AIO® Gen 2 and Gen 3 AIO® Wall Mounted Units

Summary Of Differences

This document outlines the key technical and installation differences between our Generation 2 (Gen 2) and Generation 3 (Gen 3) AIO® Wall Mounted heat pump units. These differences primarily affect connection layout, gateway integration, vent size, access points during installation, and ERV compatibility.

1. TERMINAL BLOCK LOCATION

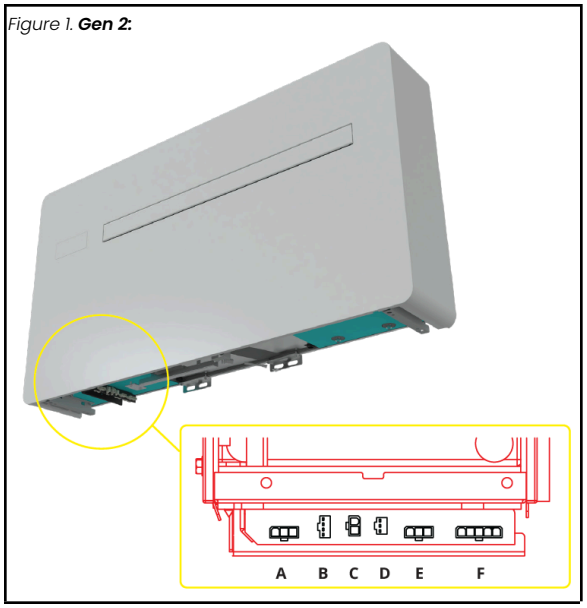
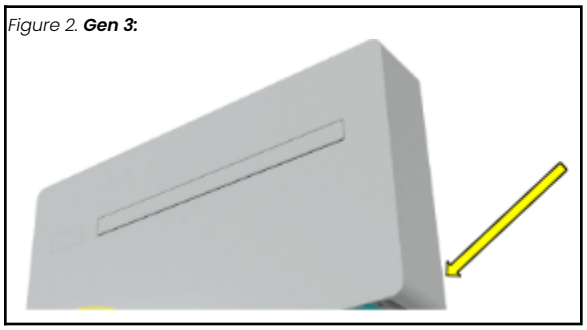
- **Gen 2:** Bottom-left side of the unit
- **Gen 3:** Rear-right side of the unit, behind the decorative side panel

2. TERMINAL BLOCK ASSIGNMENTS

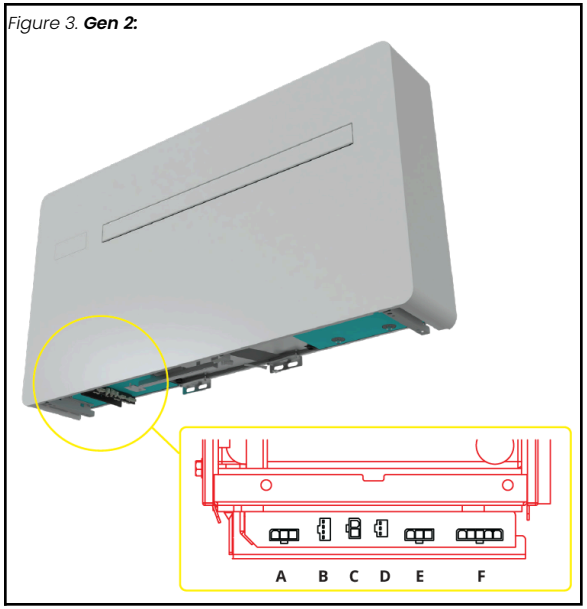
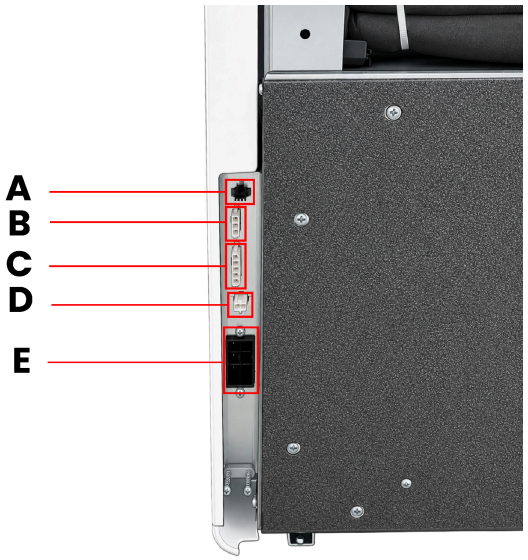
- A-Power supply for Controller Gateway
- B-Communication port for Controller Gateway
- C-Power for heat trace on condensate line
- D-Communication port for ERV
- E-Power for ERV
- F-Not used

A	ECM axial condenser fan	D	Power for heat trace on condensate line/Nebulizer
B	Power for ERV/Nebulizer	E	Quick-connect line power
C	ERV communication
